DEVIATION REQUEST AND DECISION FORM

Project Name : Paint Brush Hills Fil 14

Paintbrush Hills Filings 14 Intersection Spacing Deviation (LSC #184630)

Exhibit 1

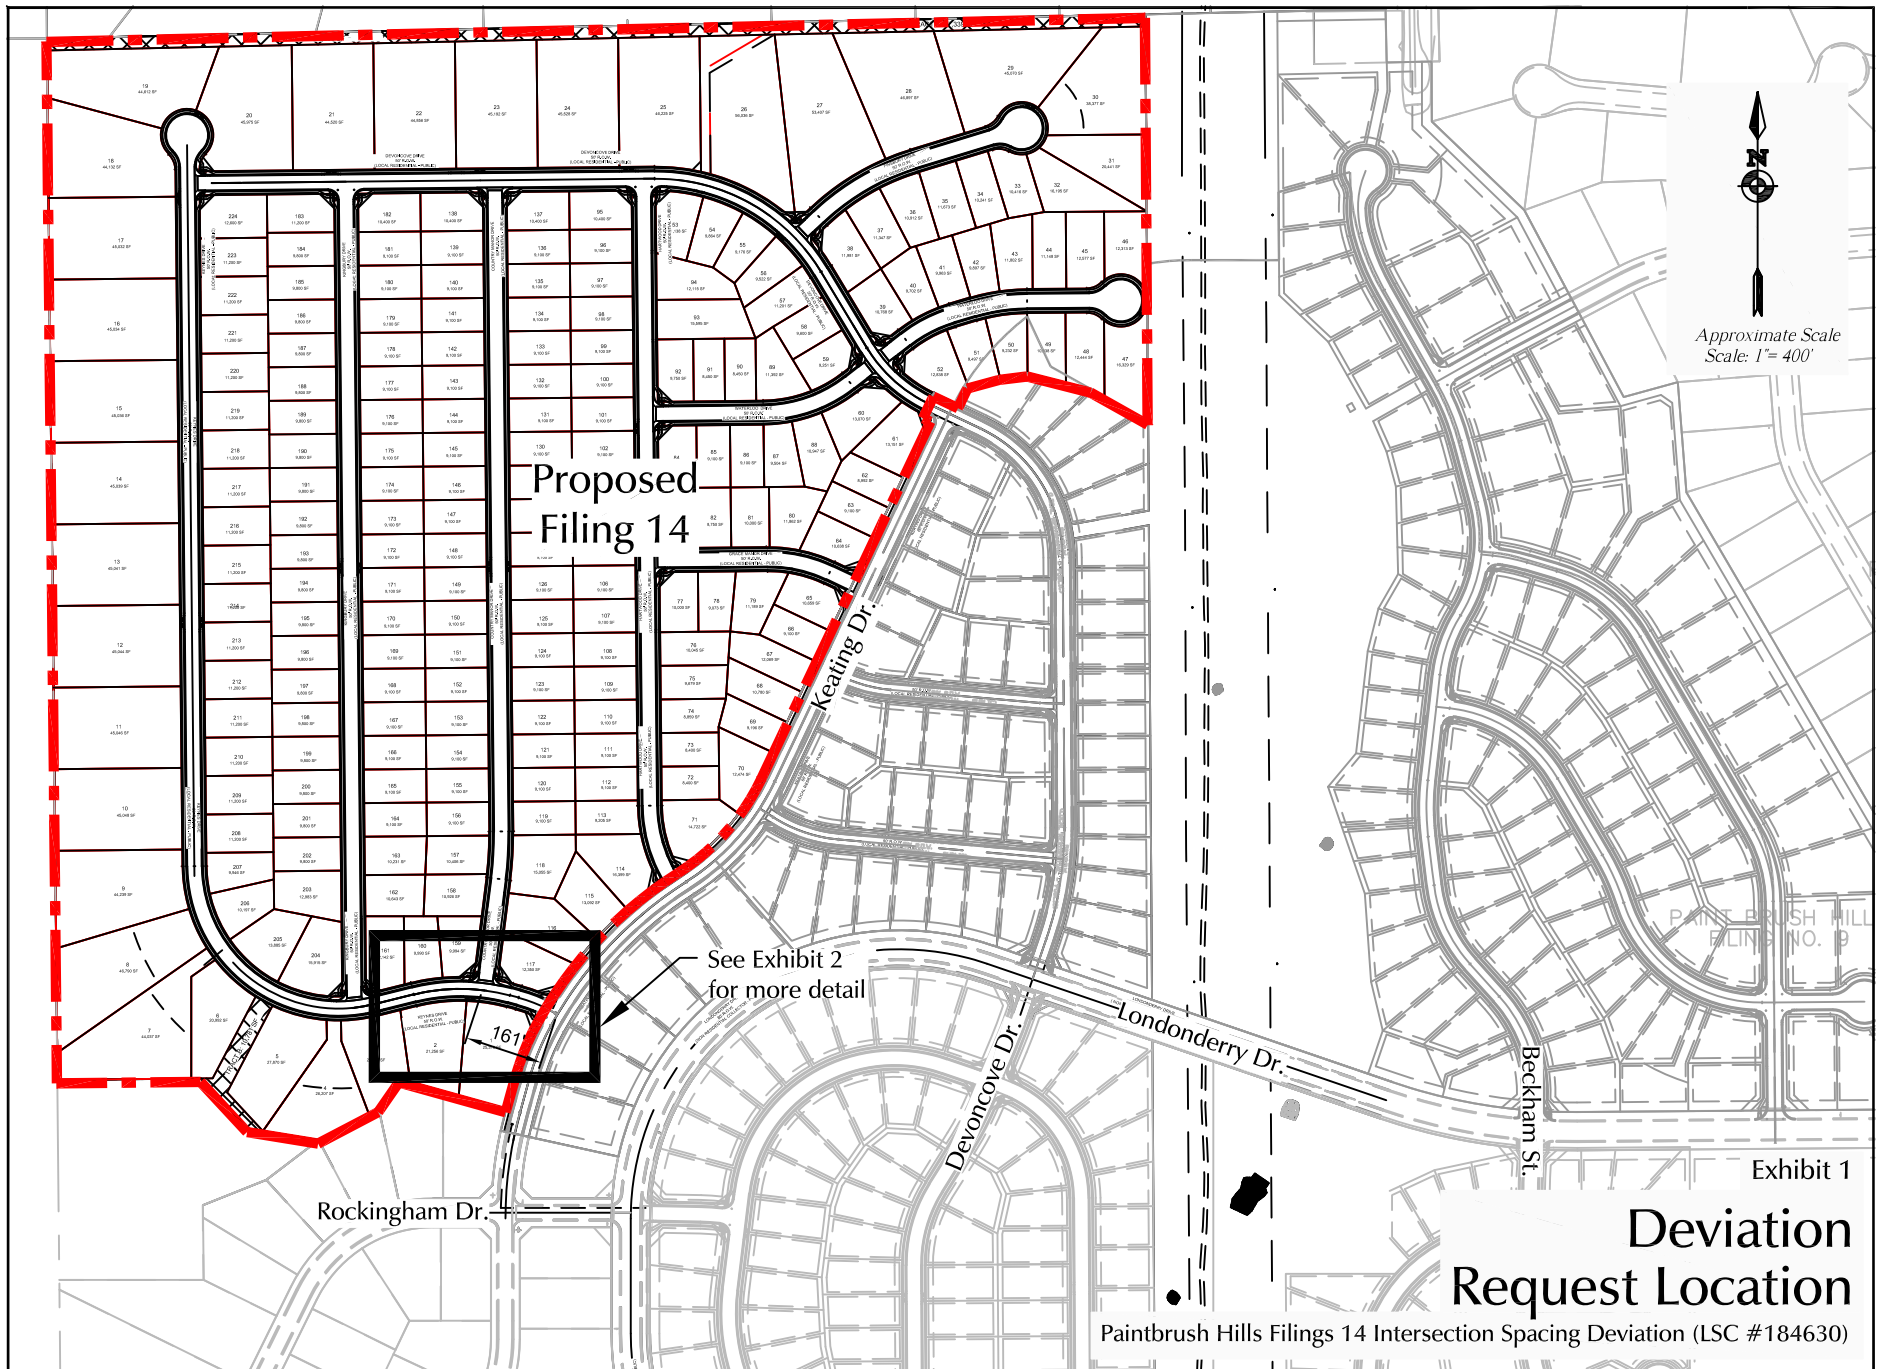
Due to the shape of the site, the need to create larger lots along the west boundary of the property, and the need to tie into existing Keating Drive, the resulting street and lot layout resulted in an Urban Local/Urban Local street intersection slightly below the 175-foot spacing criteria. Exhibit 1 shows the location of the proposed deviation.

Exhibit 2

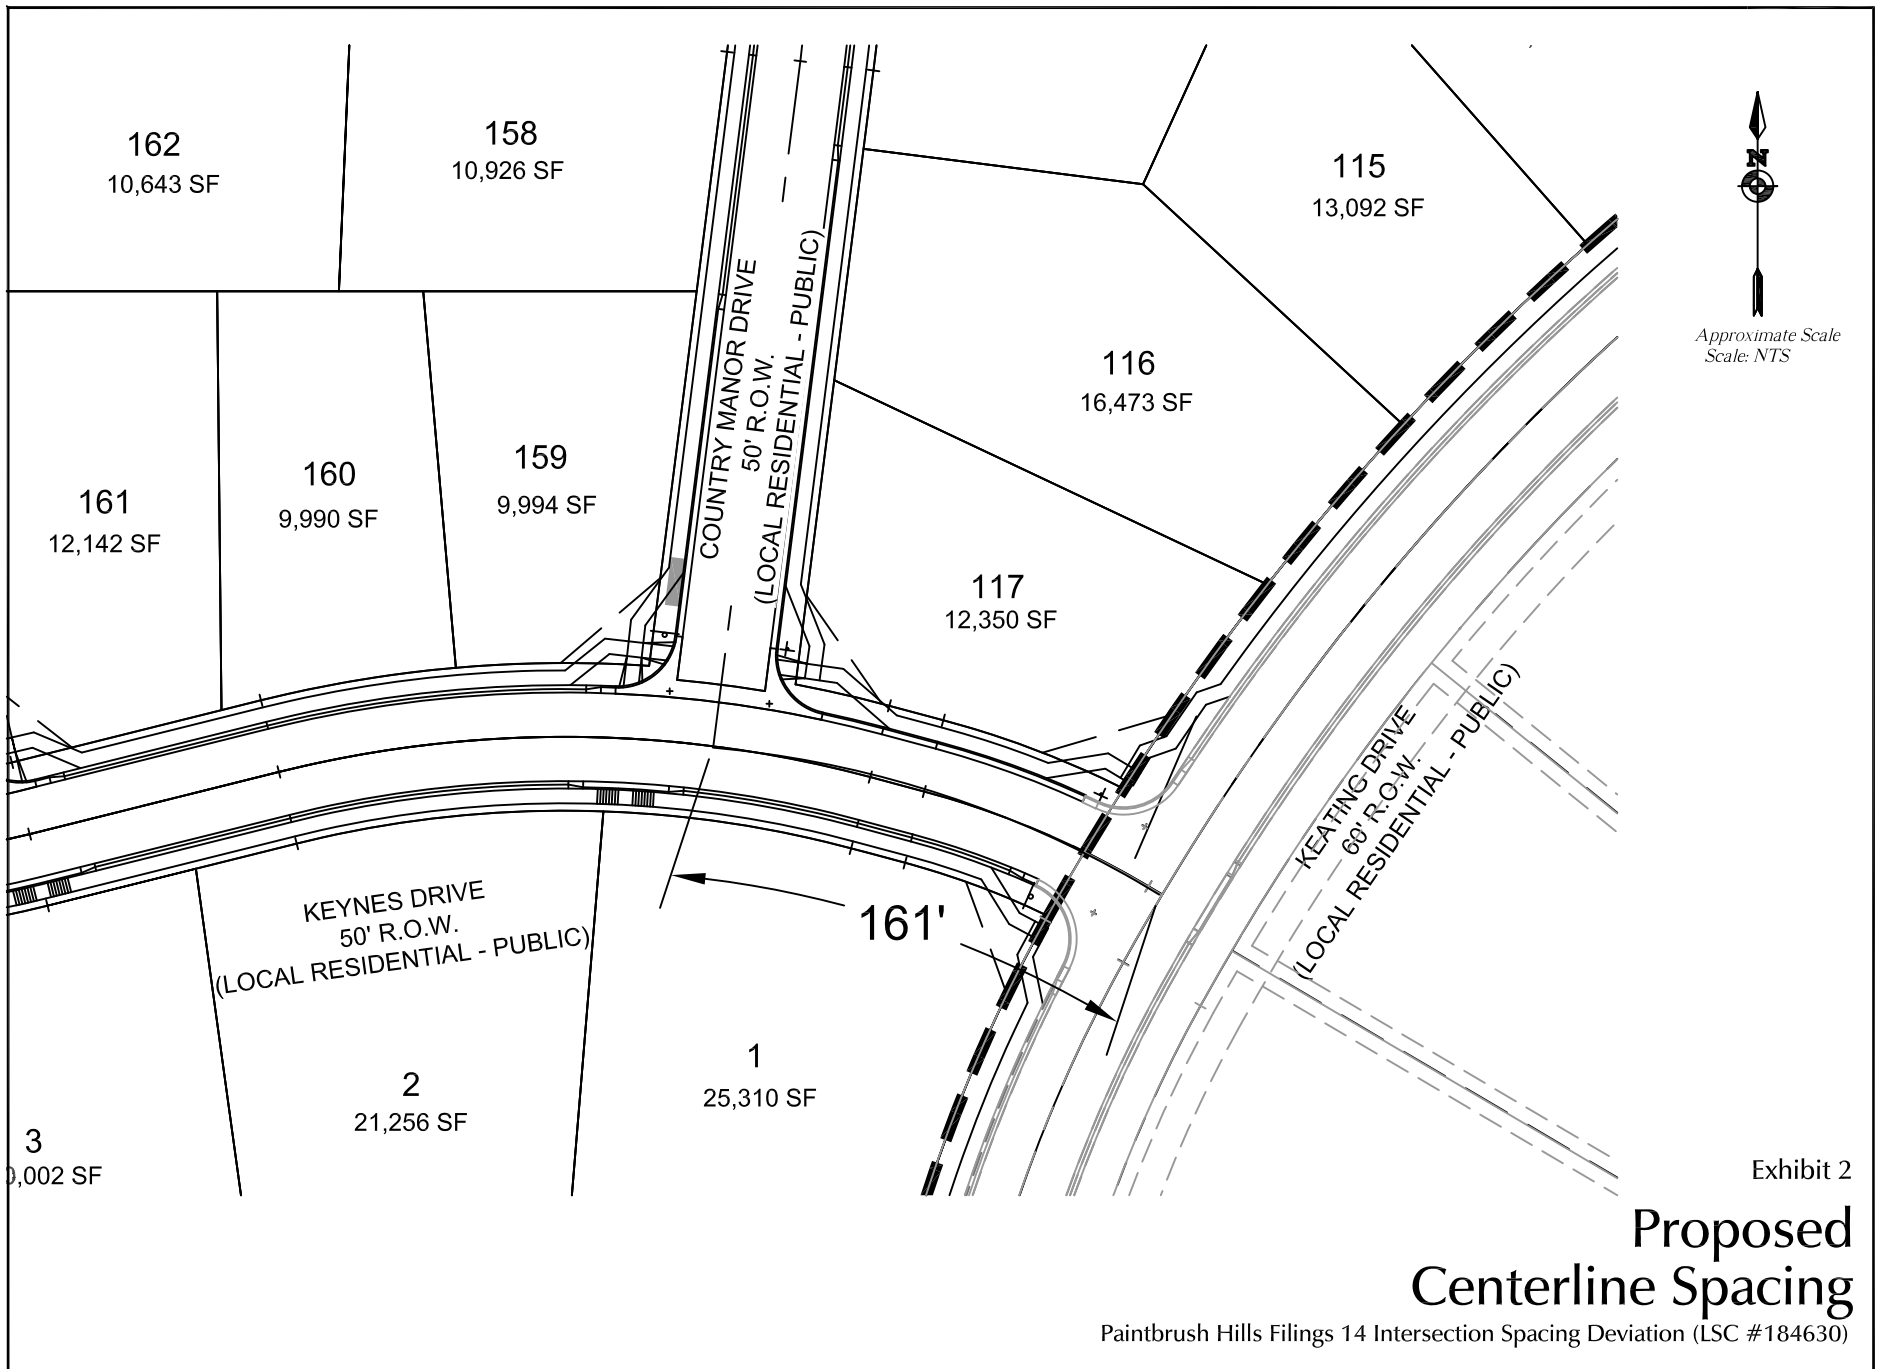
The intersection of Country Manor Drive/Keynes Drive is proposed about 161 feet east of Keating Drive (centerline to centerline). This is 14 feet short of the ECM minimum spacing for an Urban Local. Exhibit 2 shows the proposed spacing.
